**FIRST AMENDMENT TO CONSENT
DECREE RE: WHATCOM
WATERWAY SITE**

**First Amendment to
Consent Decree Re: Whatcom
Waterway Site, Bellingham, WA**

First Amendment to EXHIBIT B Cleanup Action Plan

K:\jobs\080007-Whatcom Waterway\08000701\08000701-RP-027.dwg FIG 6-5

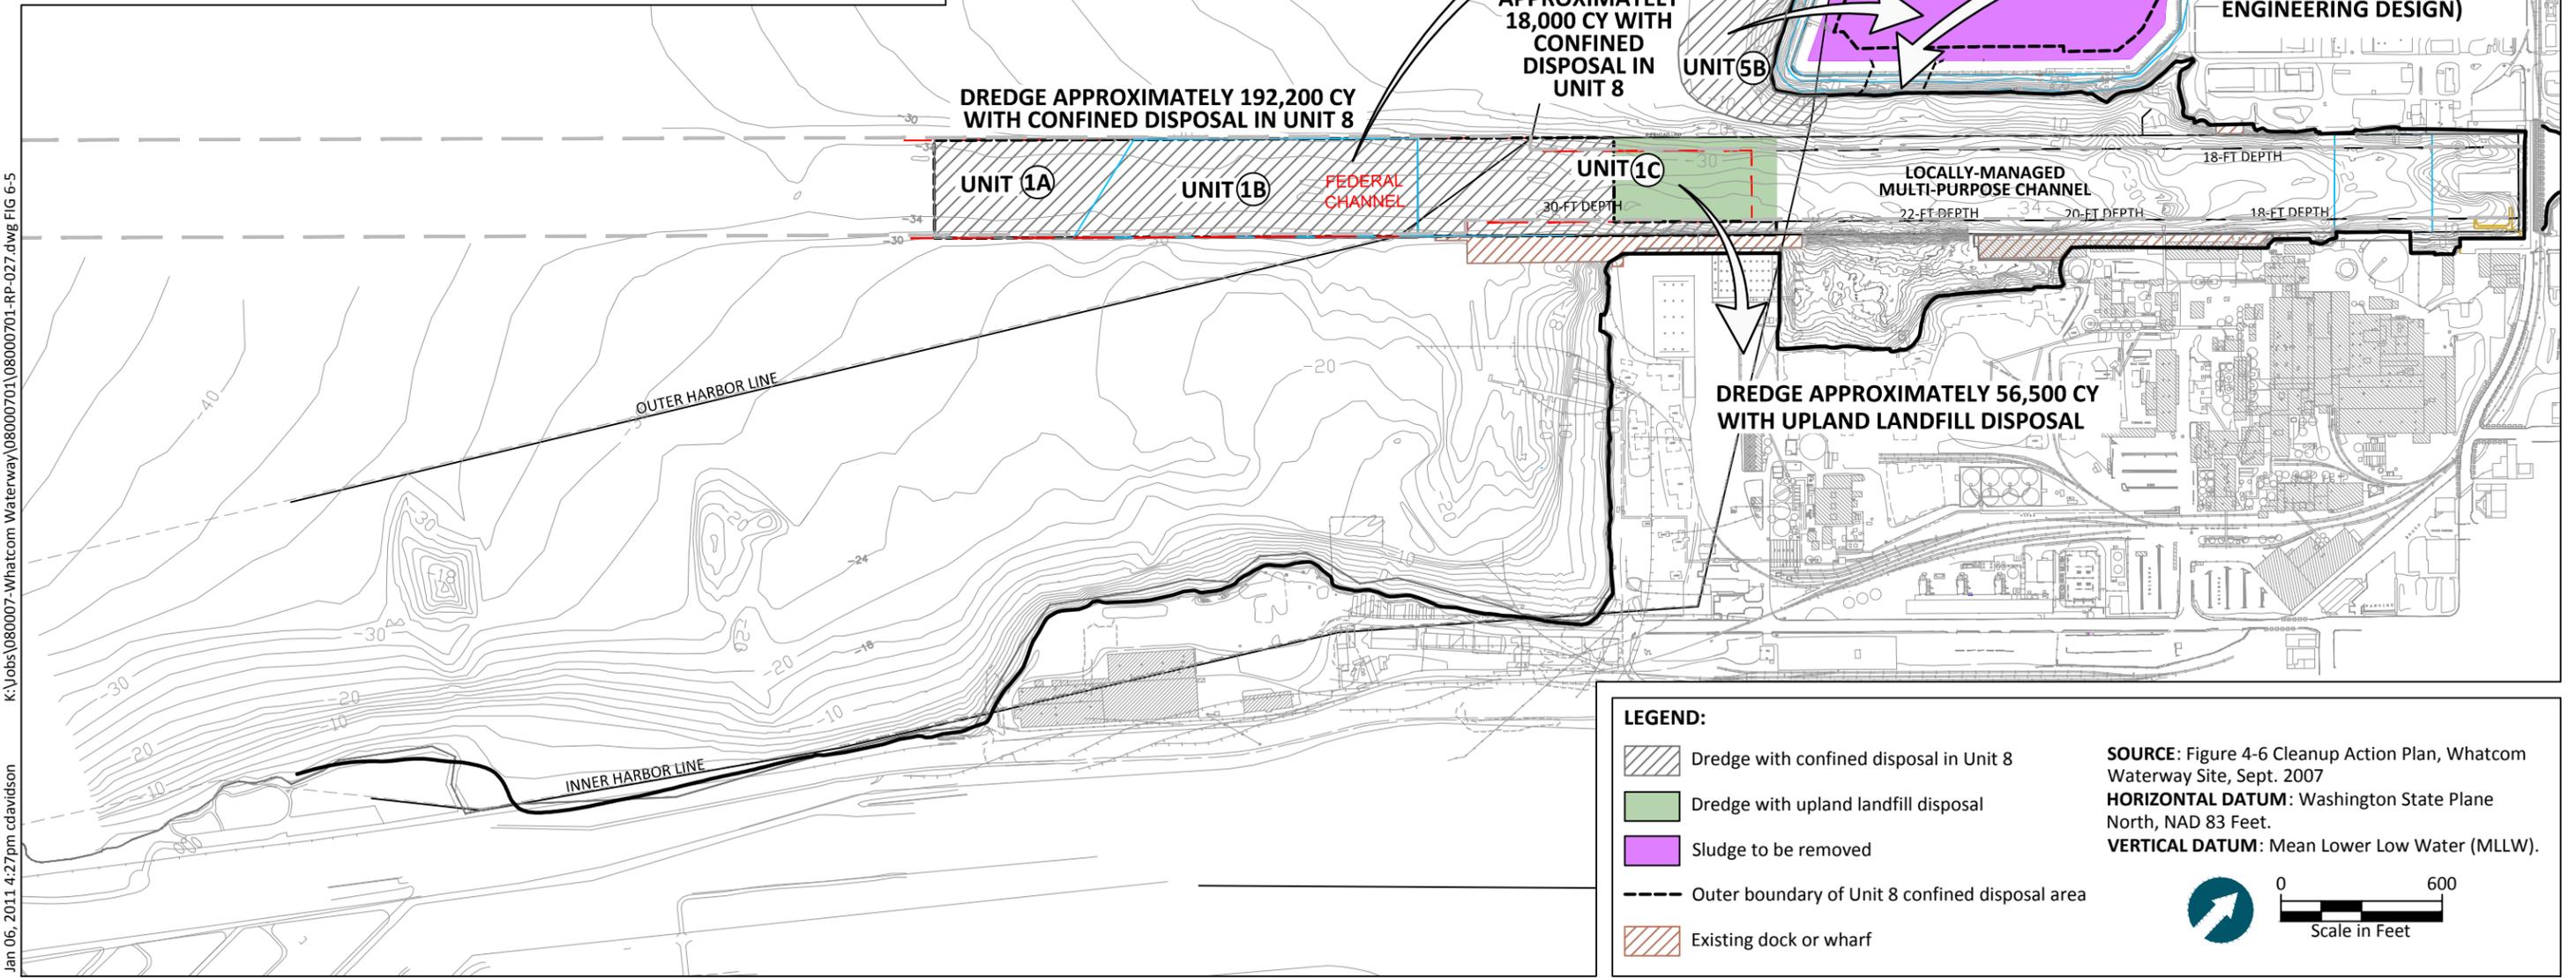
Pursuant to the First Amendment to the CAP, Figure 6-5 illustrates the elements of the cleanup action for Units 1A and 1B, a portion of 1C, 5B, and 8. Technologies used as part of the cleanup include removal with Subtitle D disposal, treatment, containment, and institutional controls.

Figure 6-5 depicts the Unit 8 confined disposal area and the average contaminant concentrations of the sediments (Units 1A, 1B, 5B, and part of 1C) placed and capped within Unit 8.

SLUDGE REMOVAL, DEWATERING AND UPLAND DISPOSAL FOLLOWED BY REMOVAL OF APPROXIMATELY 340,000 CY OF CLEAN SAND. PLACEMENT OF APPROXIMATELY 210,200 CY OF CONTAMINATED SEDIMENT FROM 1A, 1B, 5B, AND A PORTION OF 1C FOLLOWED BY CAPPING AND OPENING OF UNIT 8 TO BELLINGHAM BAY FOR PLANNED NAVIGATION USES.

Figure 7-2. Implementation Schedule - First Amendment to Cleanup Action Plan ^{[1][4]}

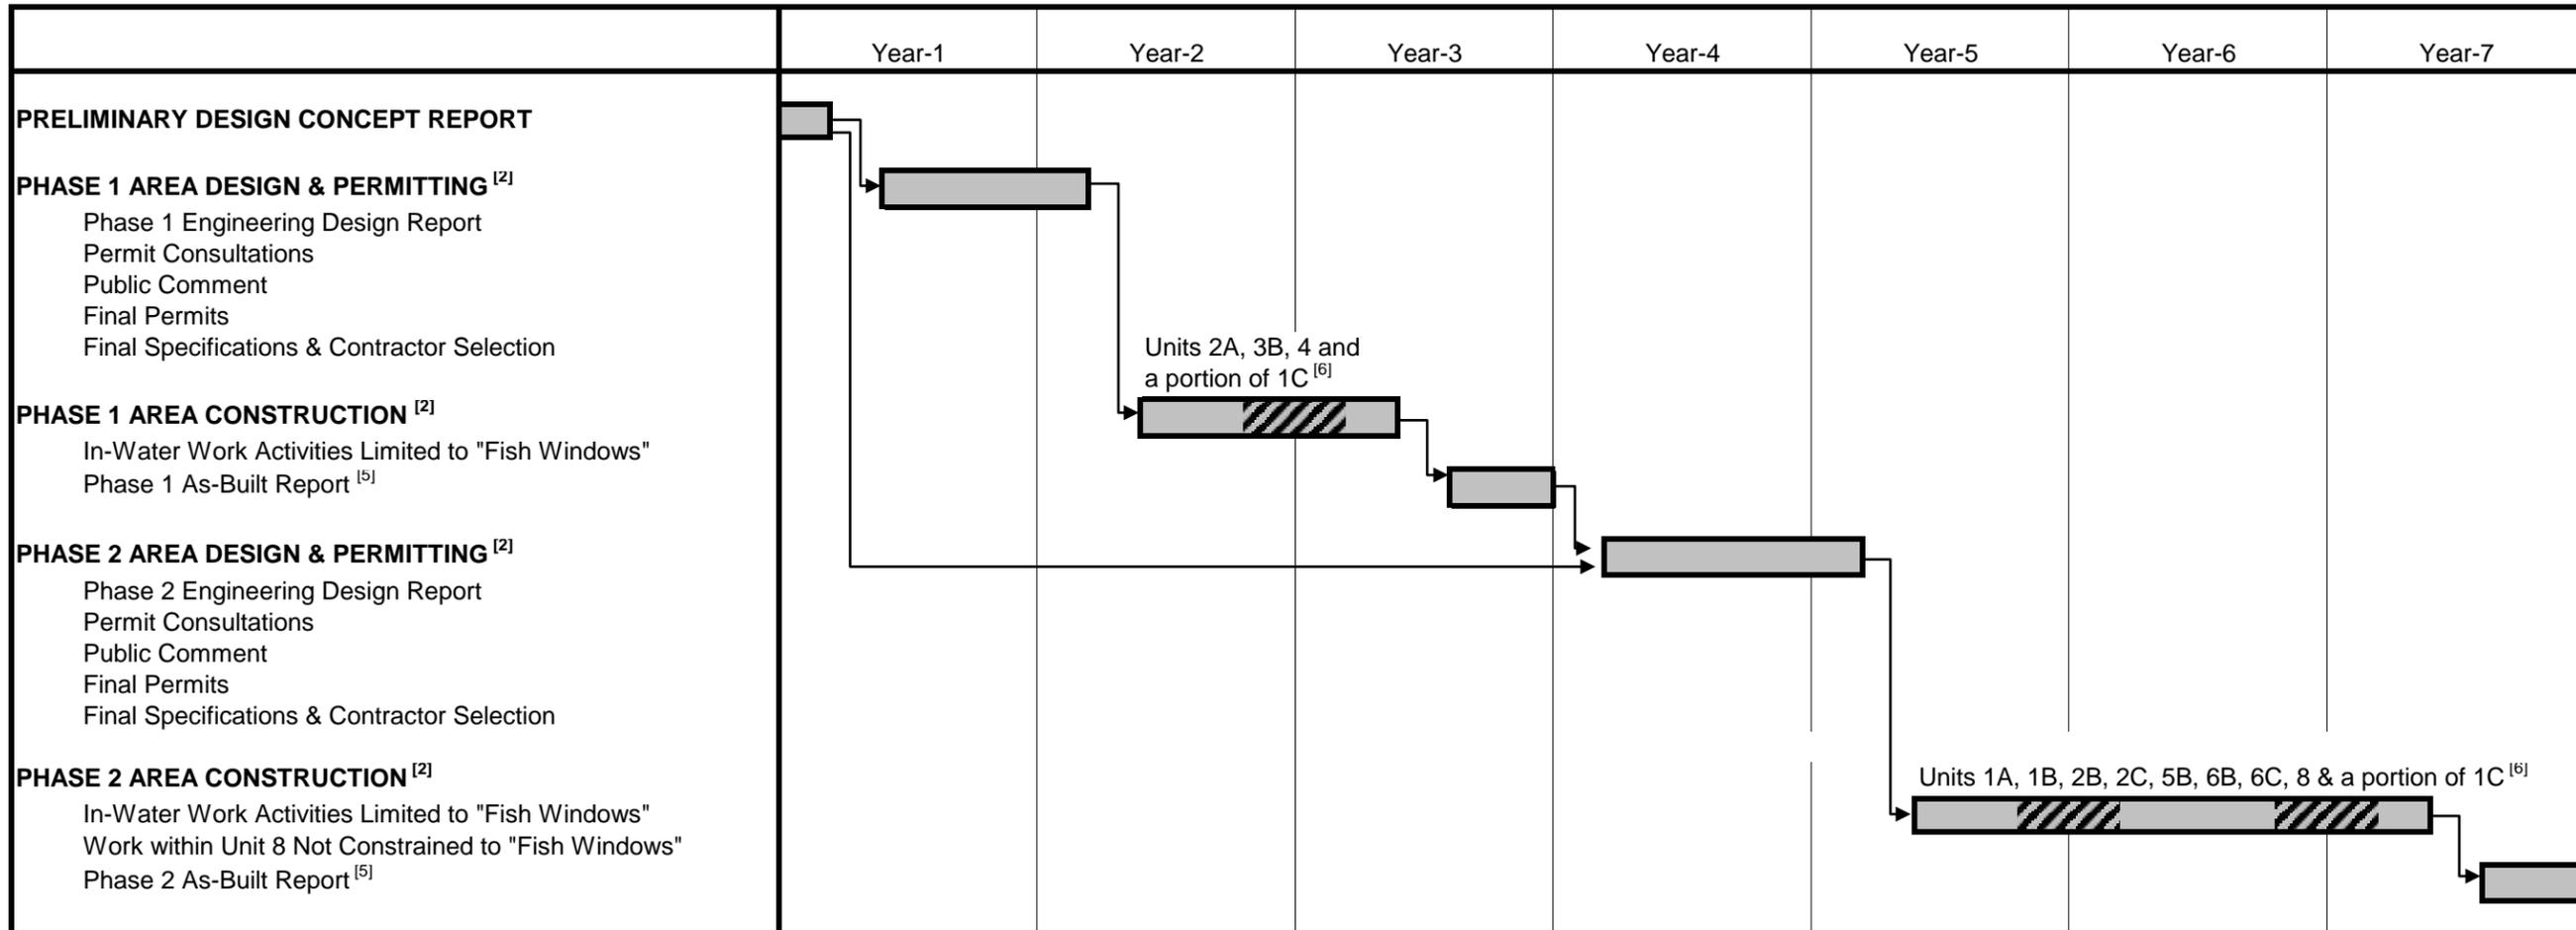
[And, Figure 7-2 is replaced with the following:]

The project schedule was also adjusted to reflect the implementation of the work as two construction actions or phases, each under its respective permits. This provides for expedited cleanup of the inner waterway, the Log Pond, and portions of the Site that are independent of Unit 8. This work also accommodates early redevelopment actions. The adjusted project schedule is attached to the Decree as Exhibit C, and is shown in Figure 7-2.

The ~~anticipated~~ schedule for design and implementation of the Whatcom Waterway cleanup is attached to the Decree as Exhibit C and is illustrated in Figure 7-2. The considerations for the schedule selected are, ~~and is~~ described below:
